**DA-836/2020 – Phase A Detailed DA
Response to request for additional information
Liverpool Civic Place, 52 Scott Street and 306-310 Macquarie Street, Liverpool**

Attachment A – Detailed response to Architectus’ request for additional information DA/836/2020 Liverpool Civic Place

**RE: Liverpool Civic Place – Phase A
Response to Council RFI – Acoustic & Vibration**

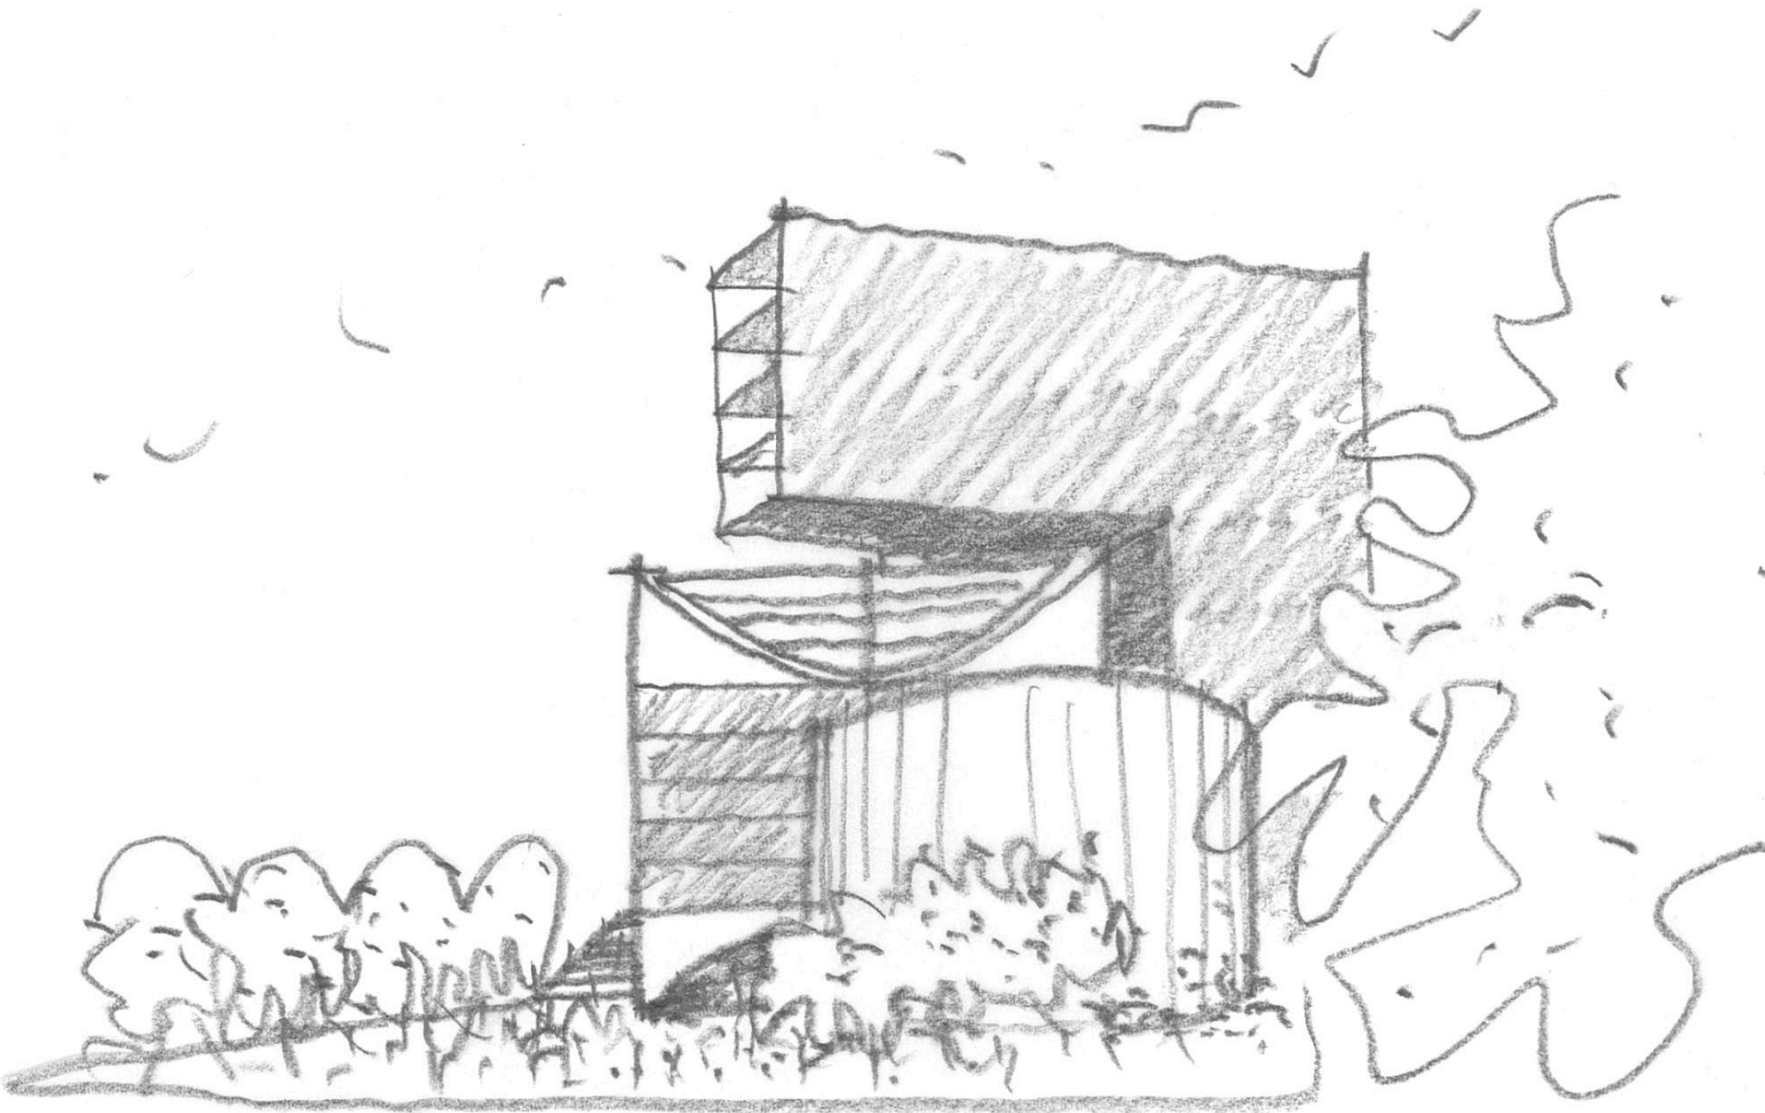
The Panel notes that there will be potential conflicts with pedestrians and cars entering the shared way. The Panel recommends the applicant to consider appropriate measures to ensure that future conflicts are reduced. The Panel recommends Council to review the traffic arrangements thoroughly at the approval stage to ensure there are no conflicts; and a traffic management plan is implemented.

Public domain plan includes physical items that prevent a vehicle travelling from the shared zone to the plaza (maximum gap of 1800mm to prevent vehicles pass between the physical objects).

Terminus Street

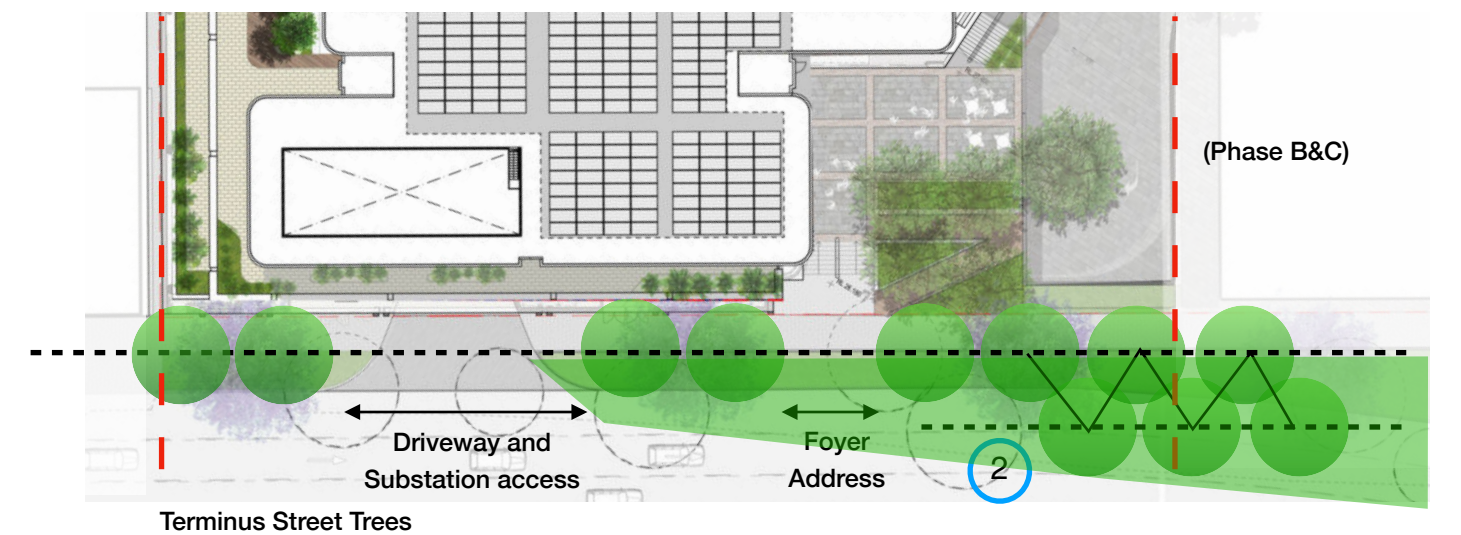
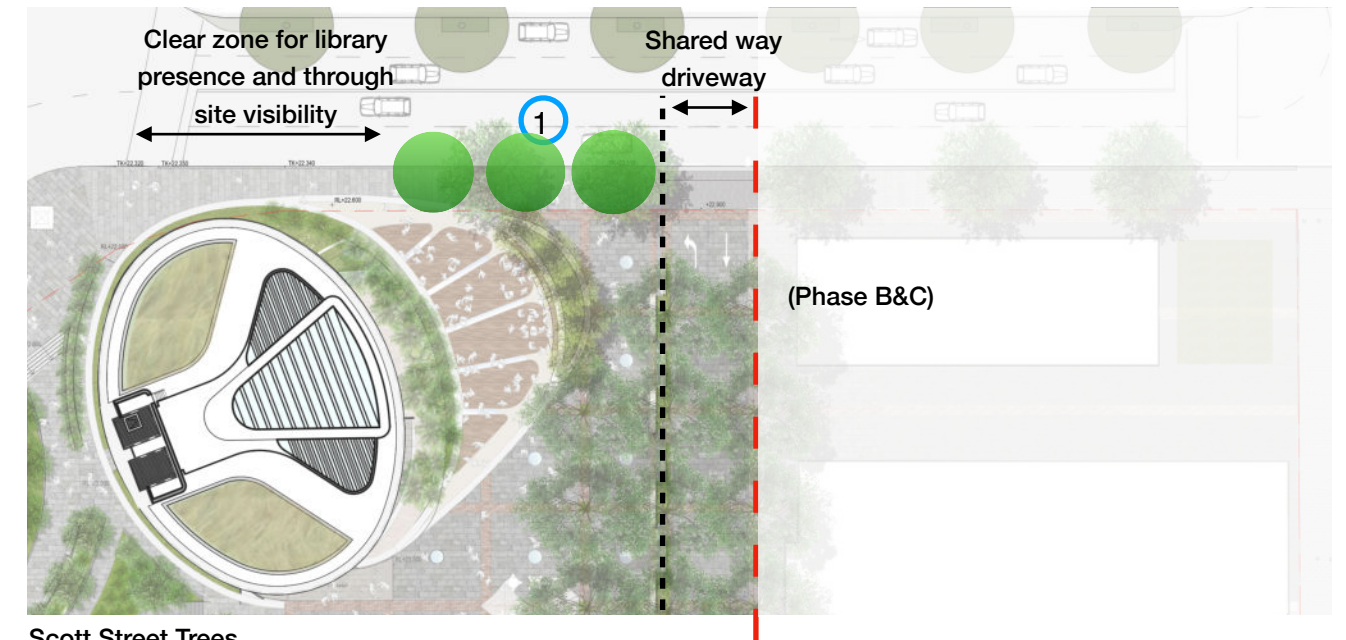
The applicant is requested to provide additional justification for the existing design solution or provide an amended design solution addressing these concerns.

The Liverpool City Centre Public Domain Master Plan (LCC PDMP) proposed for the Scott Street frontage of Phase A three Liquid ambers of 20m tall x 6m canopy cover and spaced to complement the 2019 Concept Masterplan (folded ground plane) design. Liquidambar styraciflua are deciduous non-natives.

Our proposal includes a species change to a drought resistant native evergreen, spotted gum, to create shade and weather cover at the civic domain street edge (in lieu of awnings) and signify the Cumberland Plain woodland metaphor at the gateway to the site.

The LCC PDMP proposed Jacarandas, but, in consultation with LCC, the anticipated sun access after the sites development suggests a medium-sized *lophostemon confertus* will be well suited. This is a smaller tree to the jacaranda but is a robust drought and frost tolerant native evergreen.

This species' canopies are broad at 9m. They've been spaced on a 7m offset grid to ensure canopy interlock. This canopy density is intended to create a visual and environment buffer to the arterial road and provide wind protection to the pocket park and civic plaza. The layout of trees proposed accounts for the potential future road expansion, with the southern line of trees removable should it eventuate.

1. Add 1 x street tree to Scott Street Row
2. New double offset Row of trees (13 in total)

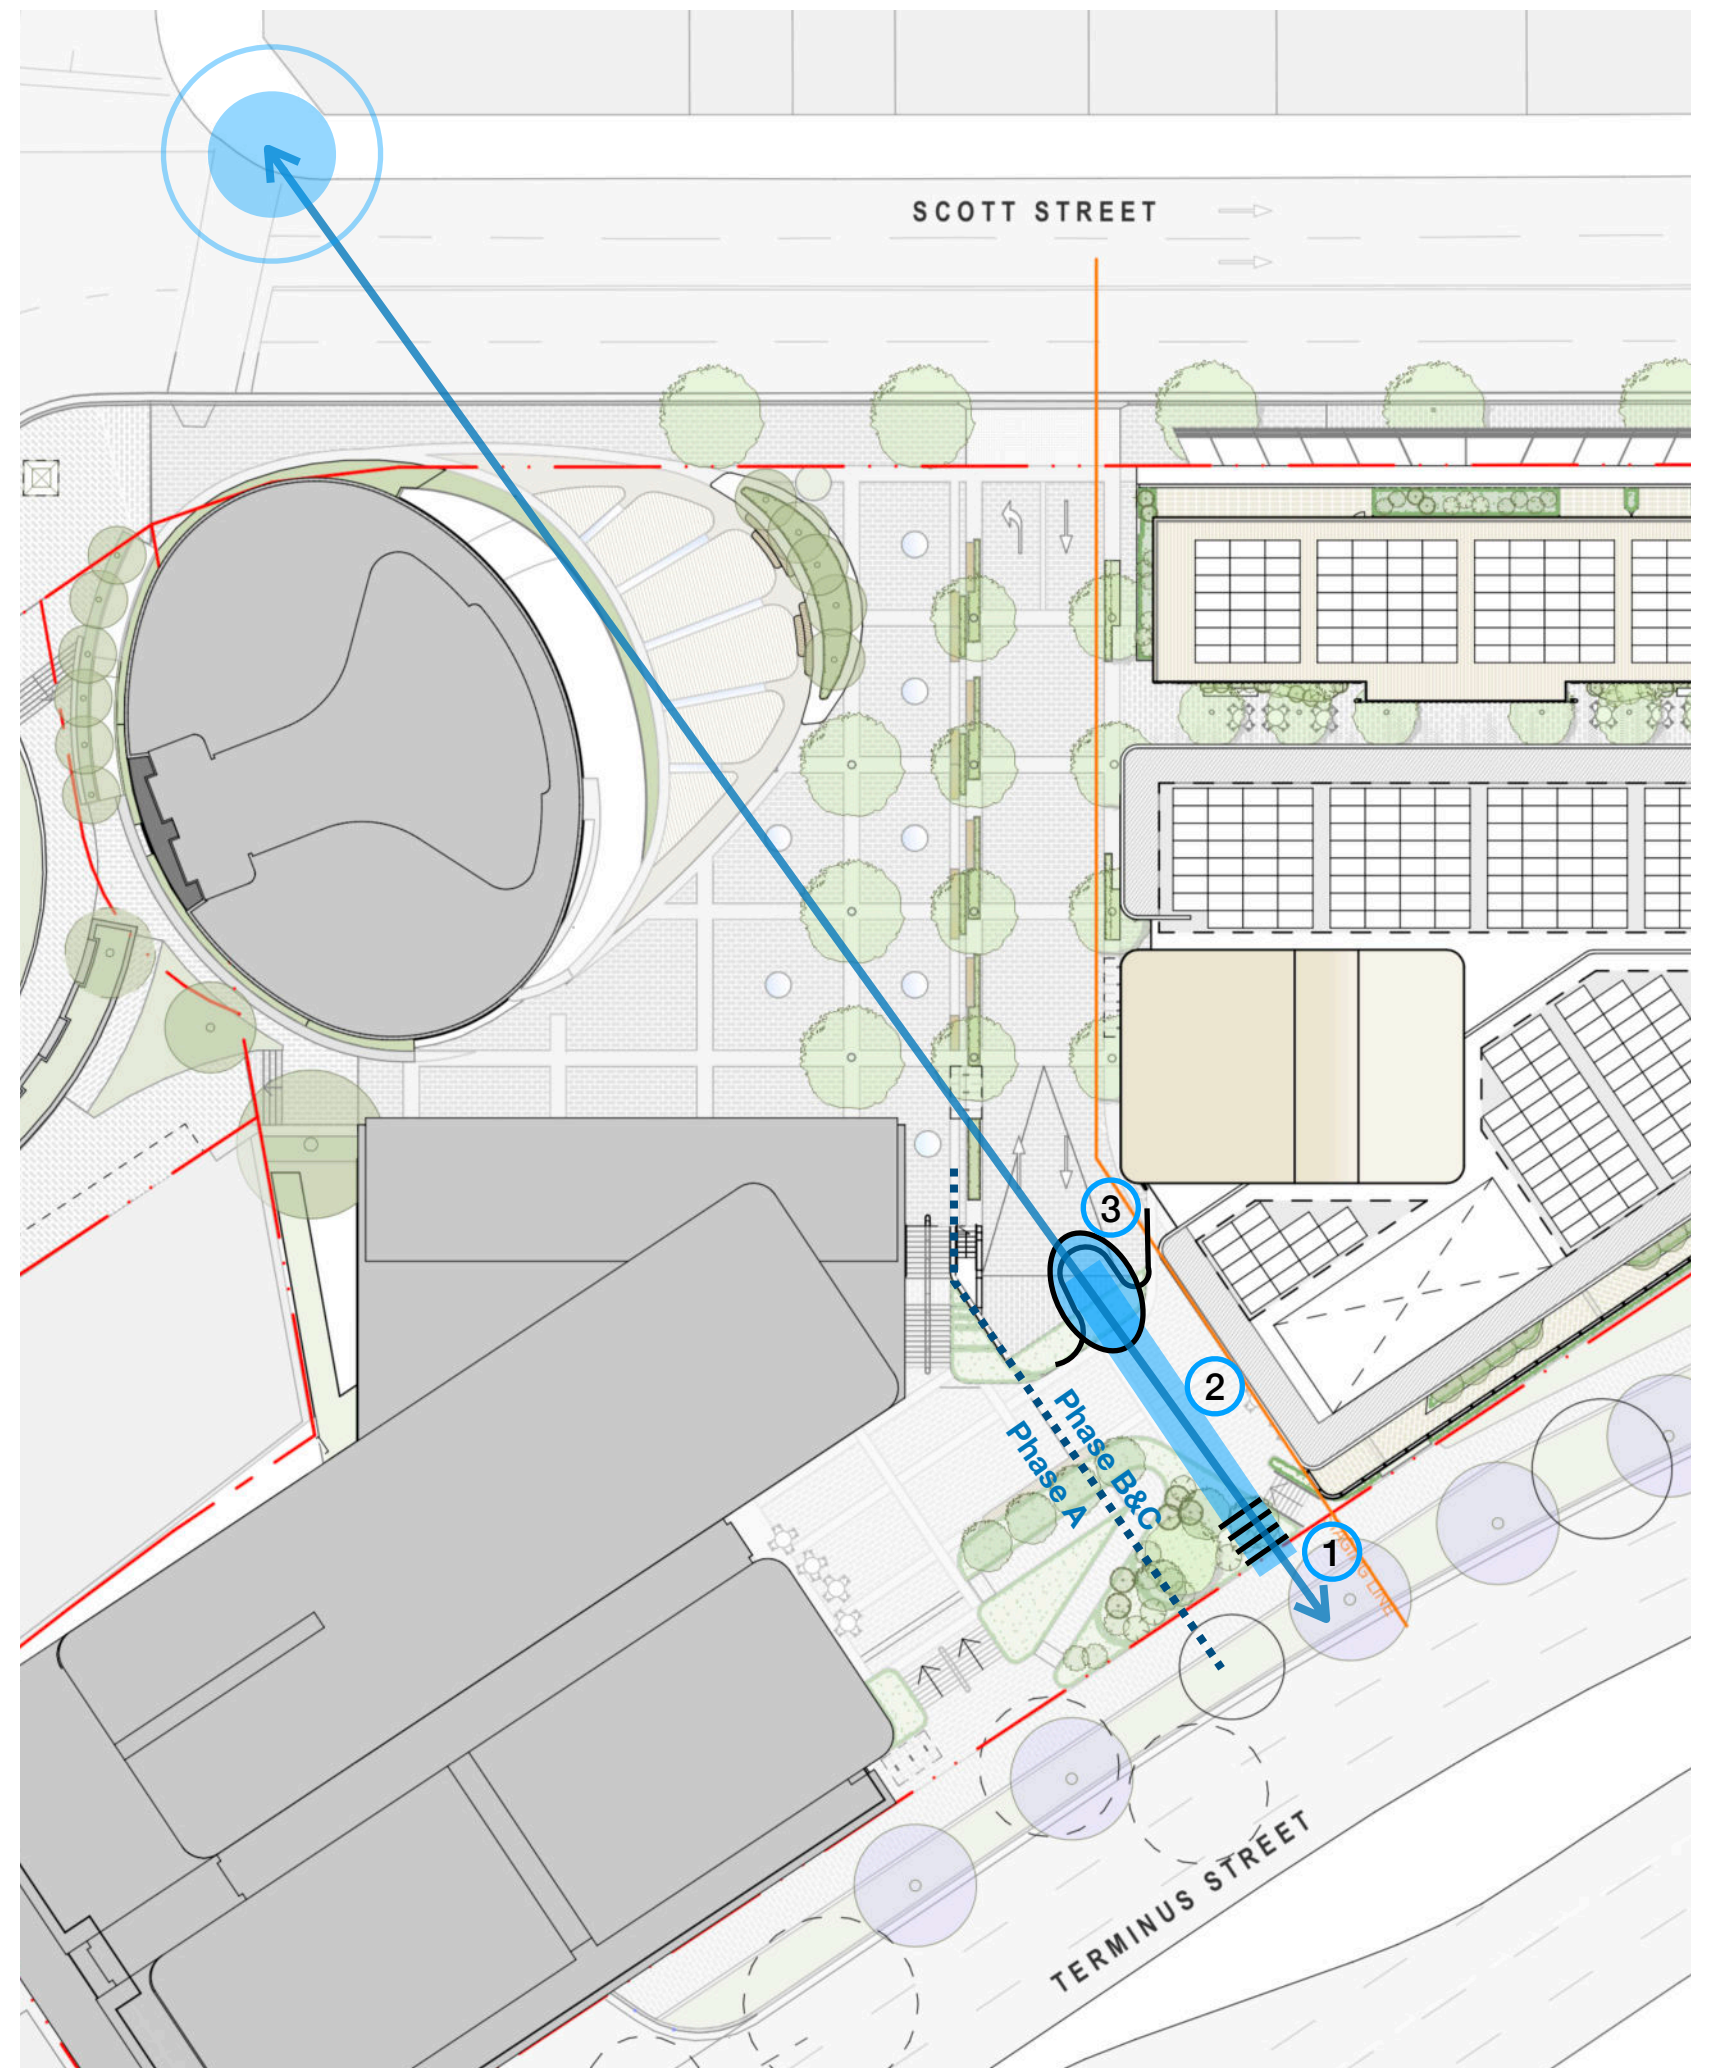
The Panel supports the design of the pocket park; however, the Panel questions the development of the pocket park in stages. **(Refer 2D(iii))**

1. The Phase B/C stair from Terminus Street will shift and rotate to sit on axis with the Macquarie Street intersection.
2. A material inlay (eg timber decking) will subtly accentuate this alignment
3. The northern edge of the Terminus street pocket park on this alignment will be a dynamic viewing platform, which will not only provide an exciting vantage point from the pocket park across the Civic Plaza, but also create an environmental queue and striking point of interest to the pocket park when viewed from the Civic Plaza.

Phase A pocket park has a limited northern edge opportunity for overlooking the civic plaza. The plaza and Macquarie street intersection is visible, however, from Terminus Street footpath.

Phase A + B&C pocket park is extended to engage with upper ground floor lobby entry and retail

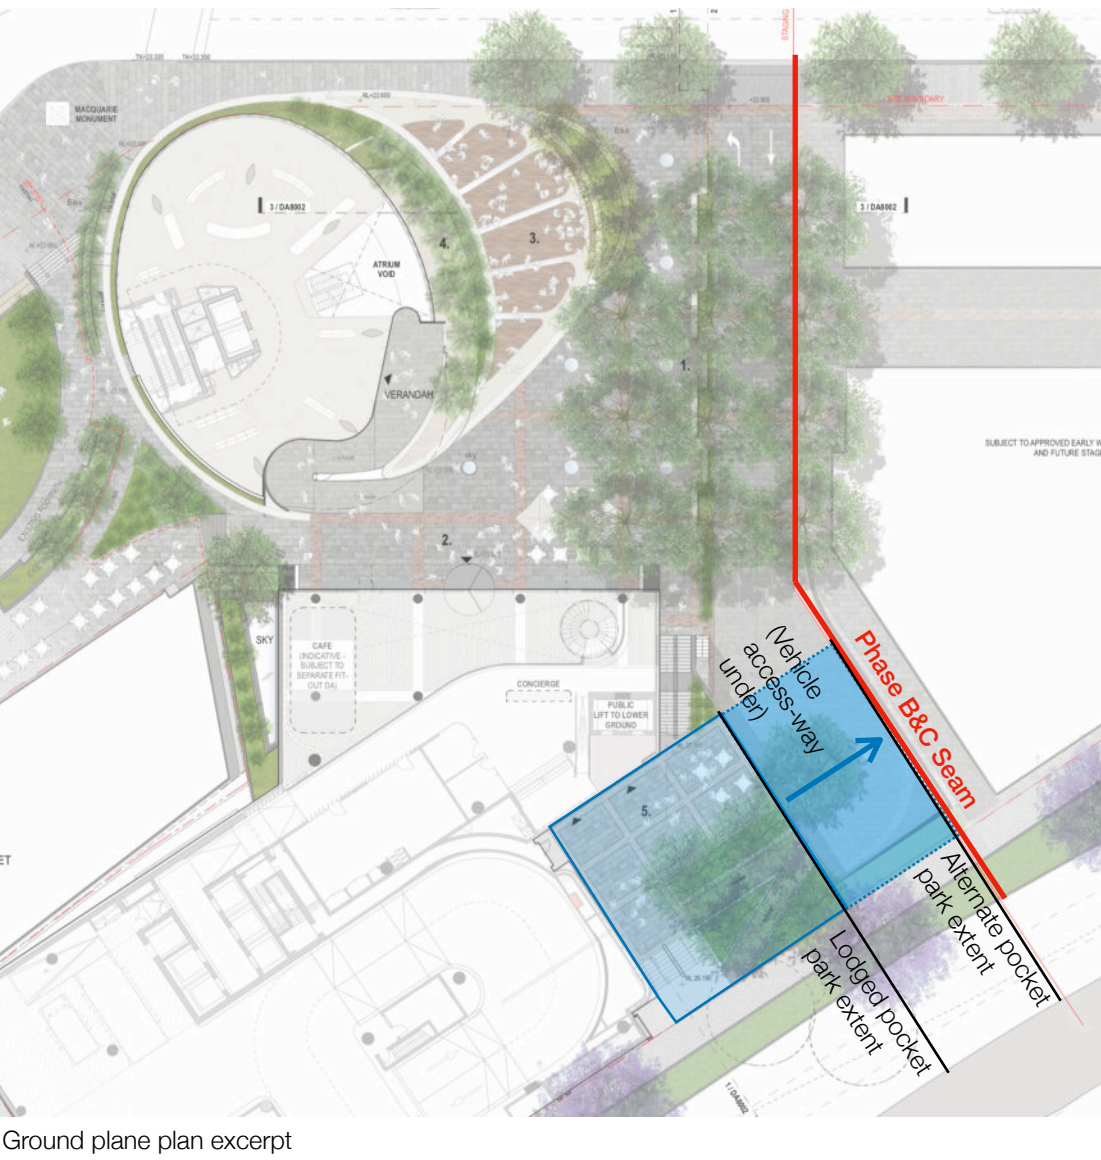
We understand this RFI to relate to Phase A's eastern extent of the pocket park under scenario 2 above.

The proposed Phase A design aligns the eastern edge of the pocket park with the western edge of the shared zone. This alignment is determined by maximising structural capacity while resolving vehicular constraints pertaining to the shared zone and vehicle entry ways below.

The resultant Phase A pocket park is a considerable public space at 330sqm, with good active-zoning including the cafe, seating areas. lobby entries and throughsite link, it receives good sun access, is well protected from Terminus street winds and traffic, and does not over-whelm the eastern edge of Phase A when viewed from the Civic Plaza.

1) **The Civic Grove**

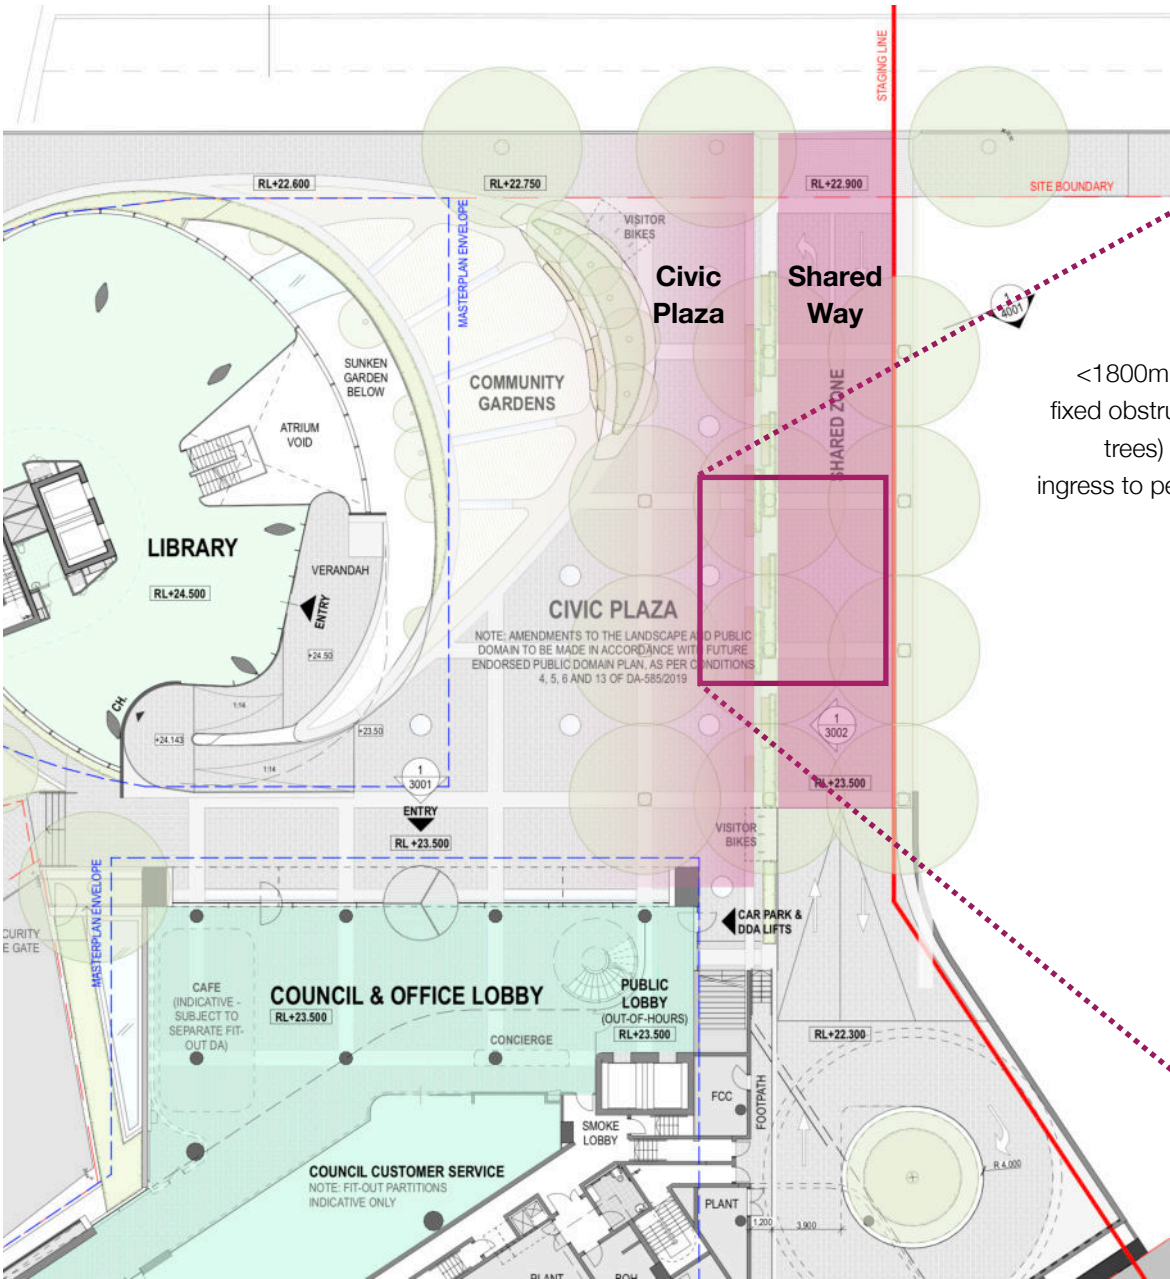
The Panel notes that there will be potential conflicts with pedestrians and cars entering the shared way. The Panel recommends the applicant to consider appropriate measures to ensure that future conflicts are reduced. The Panel recommends Council to review the traffic arrangements thoroughly at the approval stage to ensure there are no conflicts; and a traffic management plan is implemented. **(Refer 2F(i))**

This is the grid of trees within the Civic Plaza and spanning across the shared zone. A consistent canopy height is sought to present an ordered copse, consistent with the ordered tree positioning informed by the gridded material inlay. Think Champs-Elysees, Paris. The defining parameter for canopy height will be the clearance required for service vehicles to enter and exit amongst the shared zone trees, or, 4m minimum. This parameter will ensure very clear site lines across the public domain.

Crescent planter bed at the junction from timber decking to stone paving, the planting strategy here is to provide shade cover for the seated edges of the planter. Ground level visibility will not be impeded by the proposed trees.
